RE: **Lot 21 Block 1 Volcano Cliffs SAD 227**
6905 Rimrock NW
Grading and Drainage Plan
Engineers Stamp Date 6/15/17 (D10D003D008)

James D. Hughes, P.E.
Principal Engineer, Hydrology
Planning Department

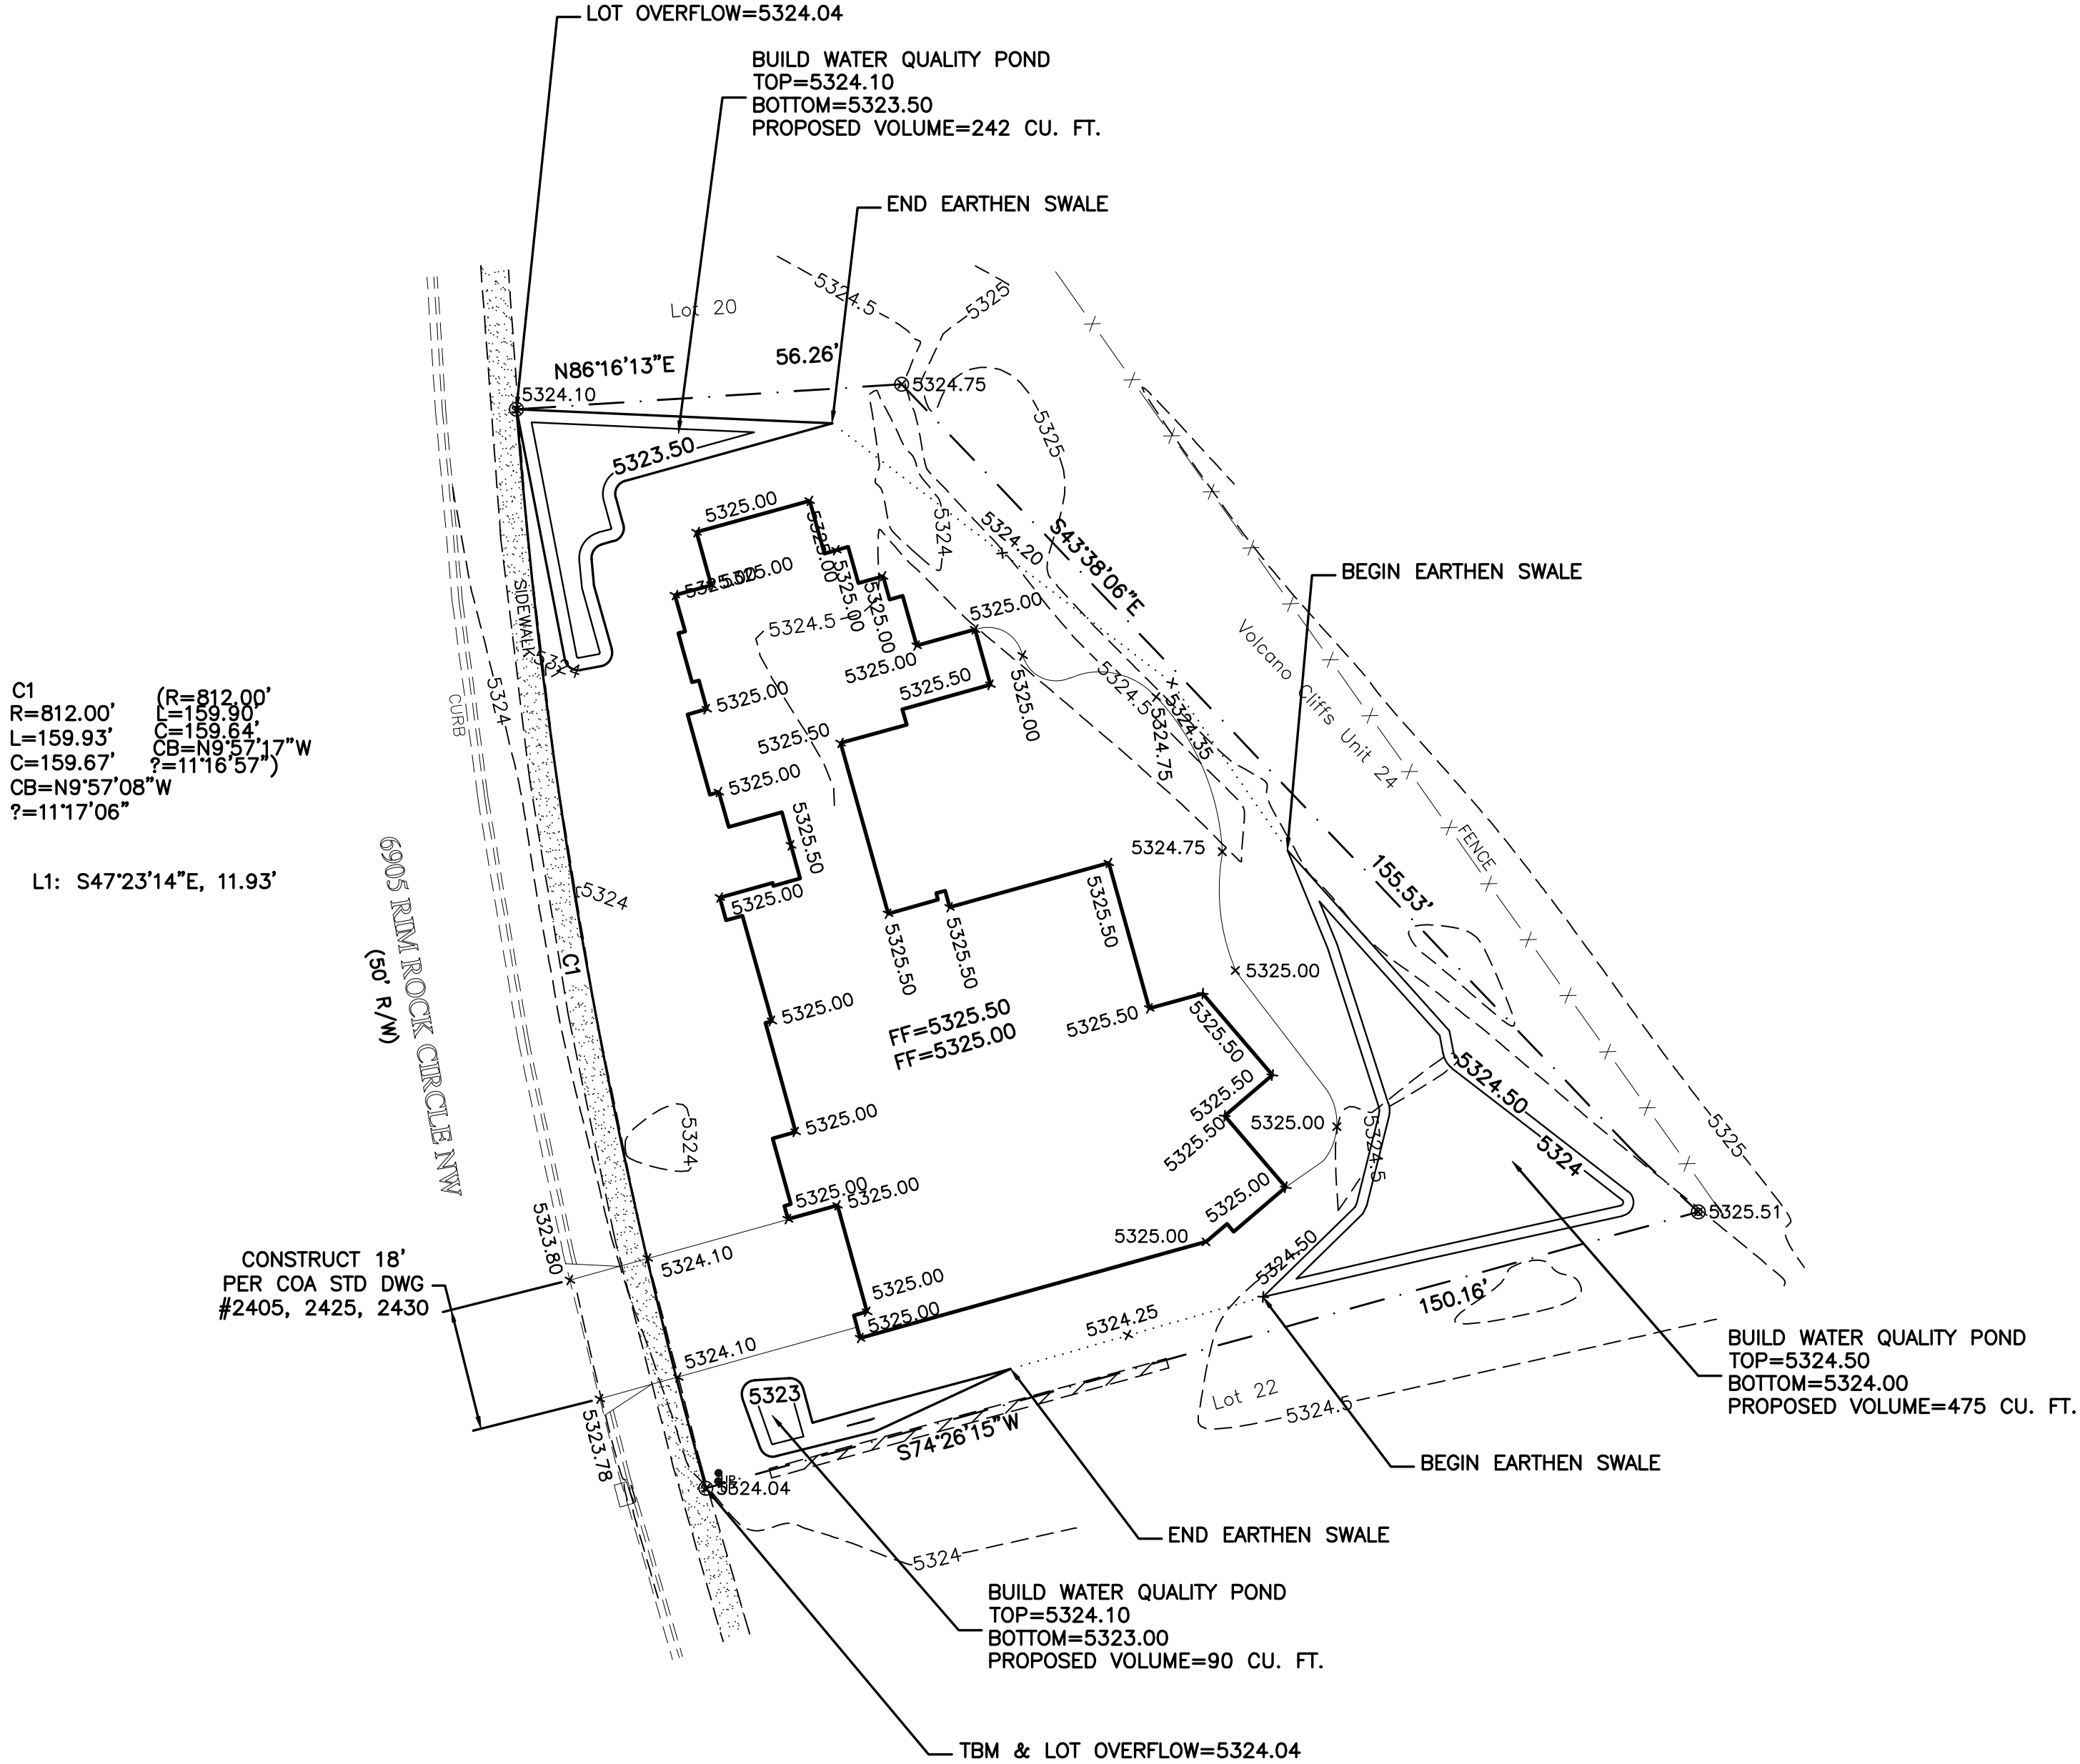
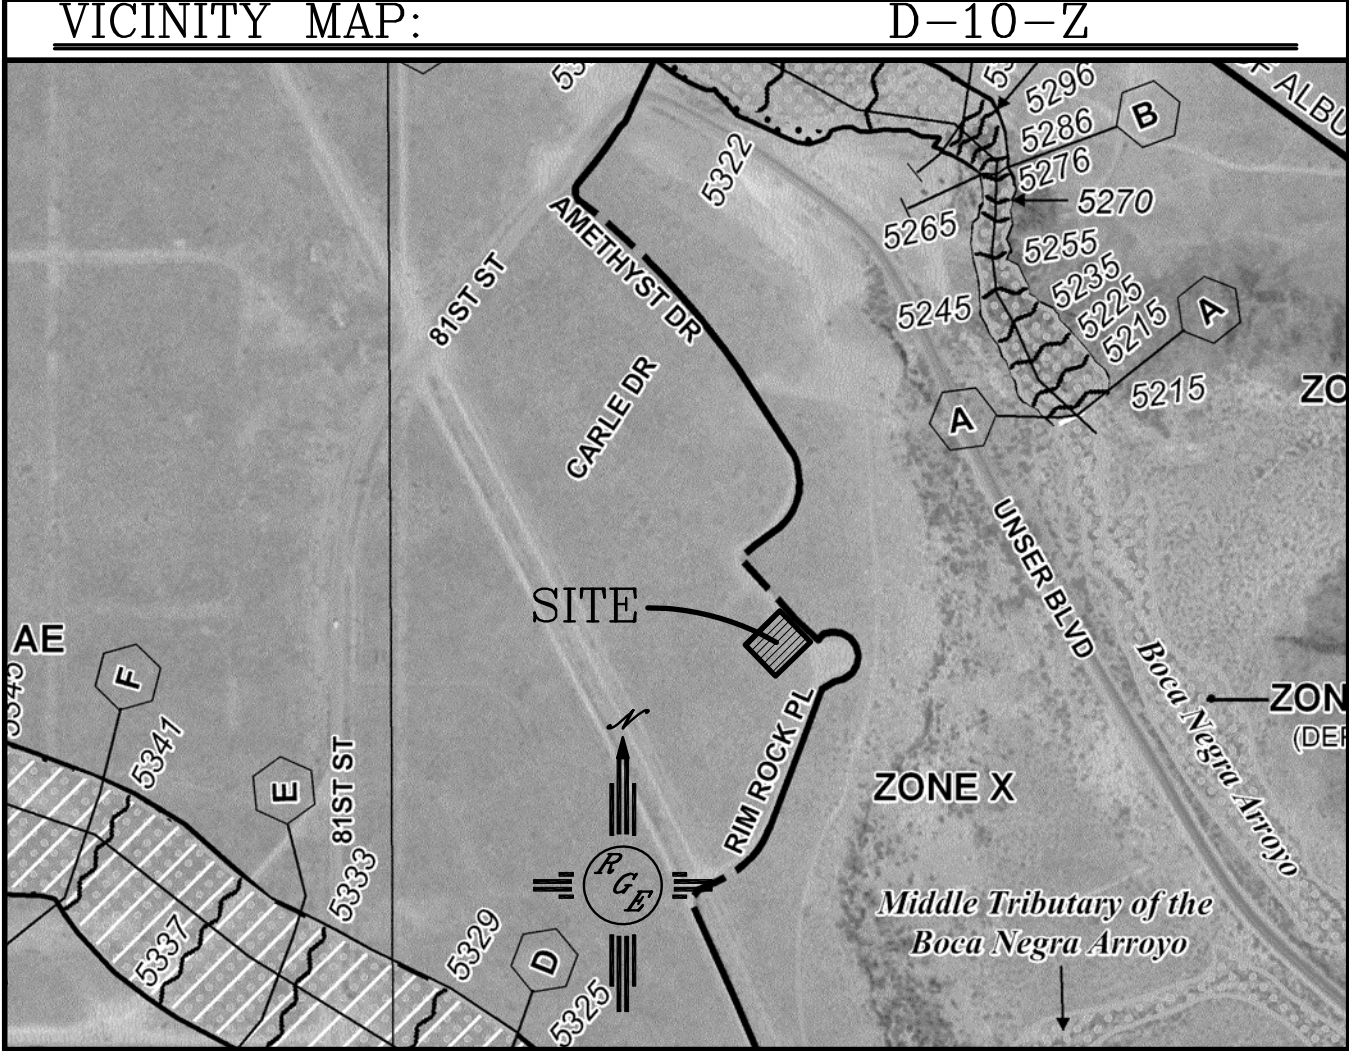
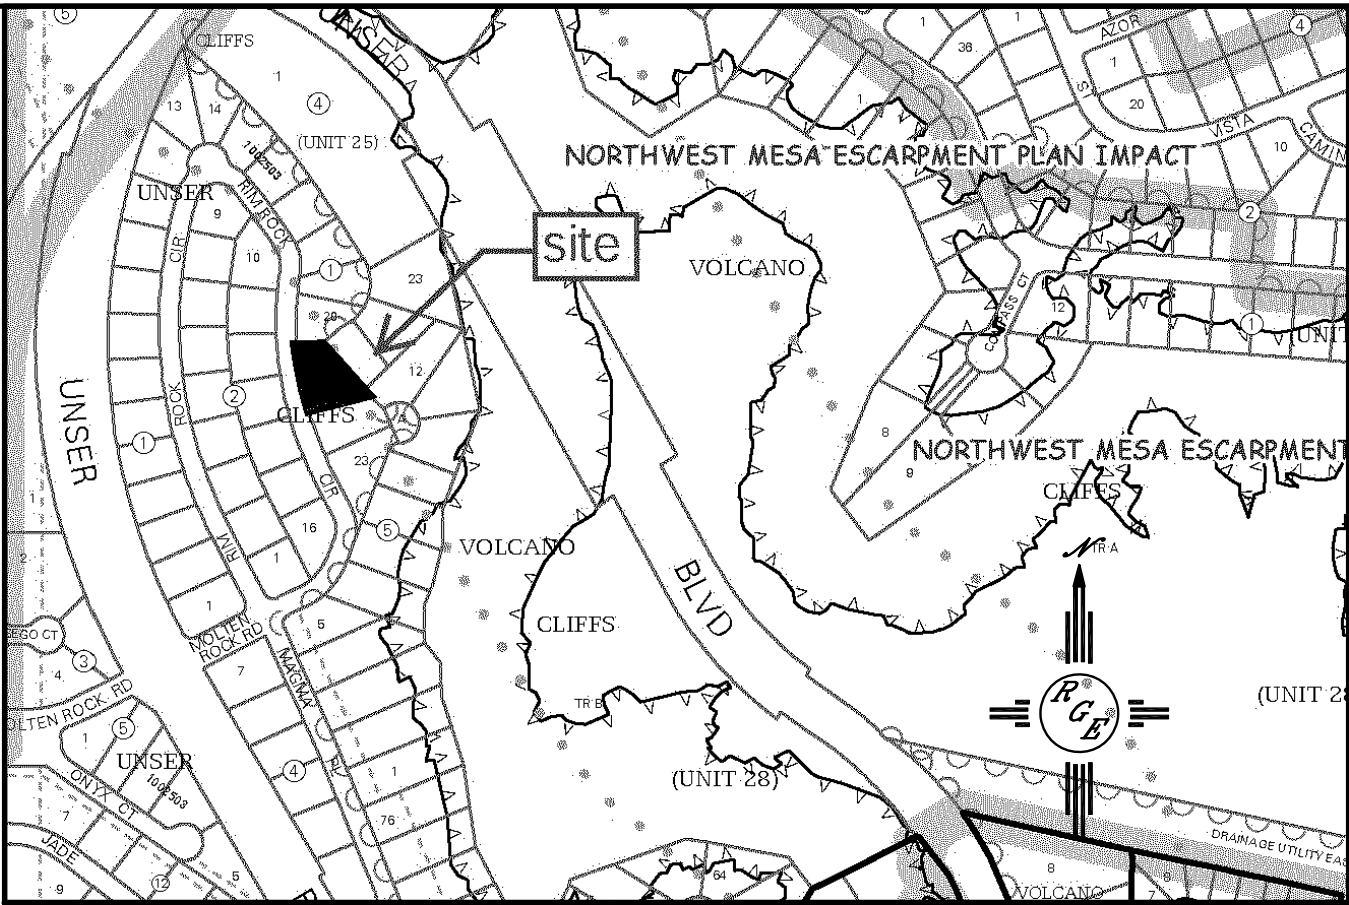
Based upon the information provided in your submittal received 6/21/17, this plan is cannot be approved for Grading Permit until the following comments are addressed.

- Provide a statement on the plan that this grading plan must be used for the application of any garden/retaining walls.
- Provide a statement that a Pad Certification is required before building permit can be approved.
